Preliminary Review of The Katy Corridor Coalition Concept

April 18, 2003

*Prepared for the Houston District of TxDOT
by Parsons Brinckerhoff Quade & Douglas, Inc., GEC*

IH 10 FROM BELTWAY 8 TO WASHINGTON AVENUE

EXHIBIT 10C

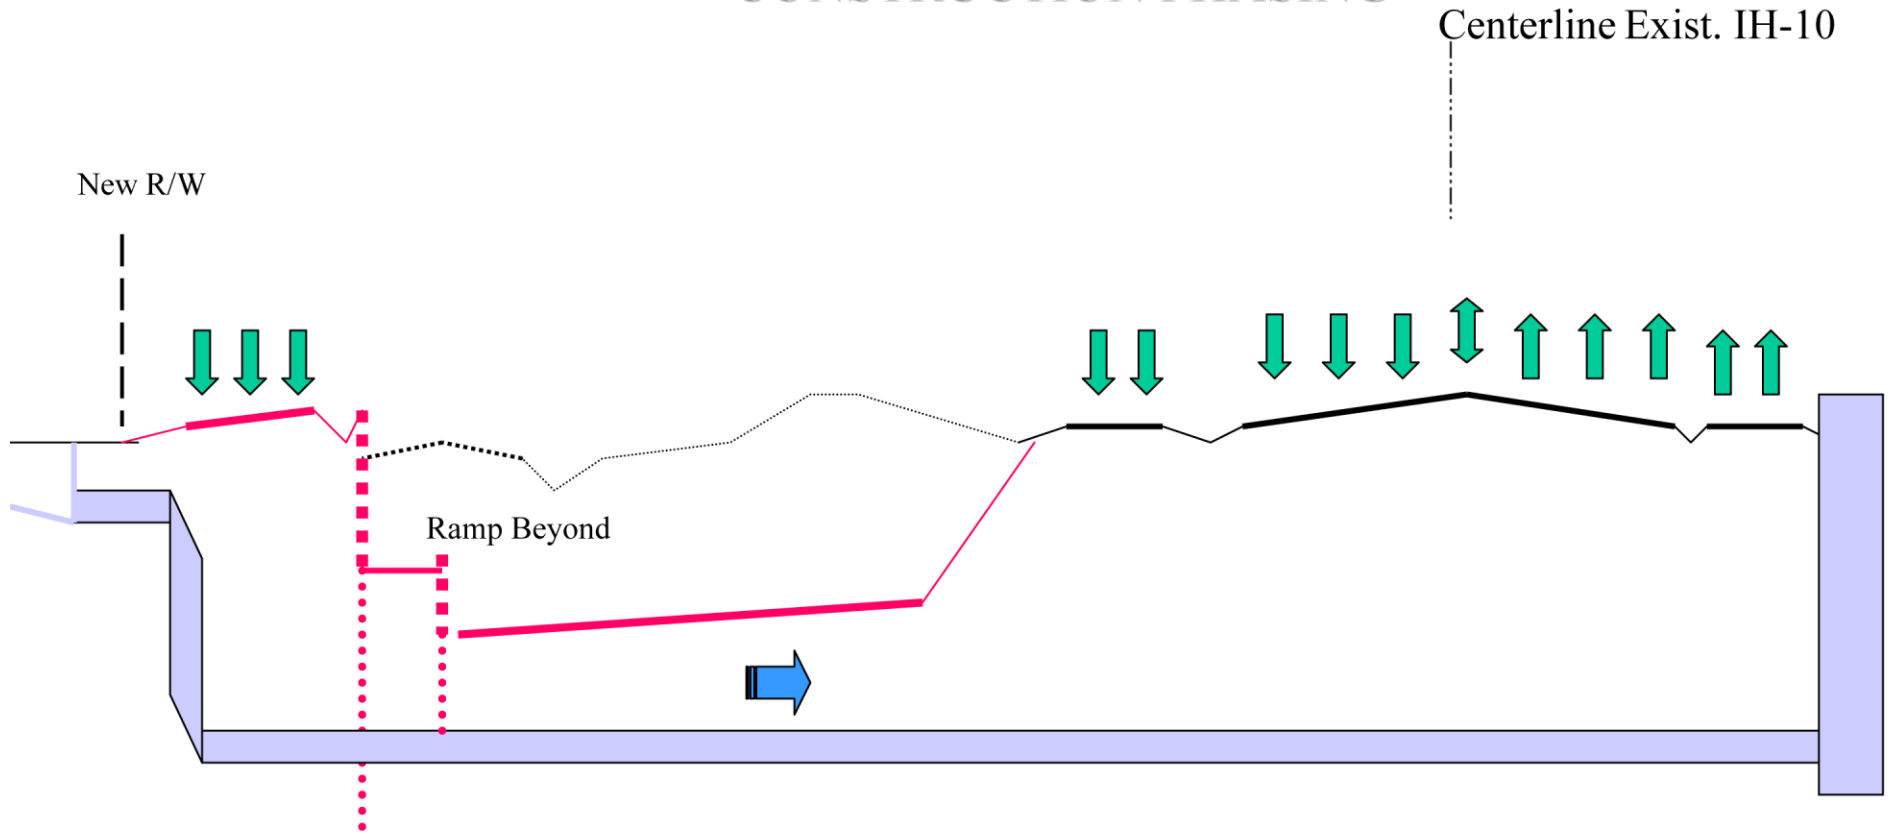
In Phase II (Exhibit 10C), the depressed westbound mainlanes would need to be excavated with a layback slope on the south side of the excavation. The extent of excavation would be limited so that the lay-back slope of 1.5:1 intercepts the surface north of the existing west bound frontage road. Within the limits of the full depth excavation the pavement structural section would be built. All existing traffic would still be operating in its current location, but the new westbound frontage road would be placed in service to provide access to abutters.
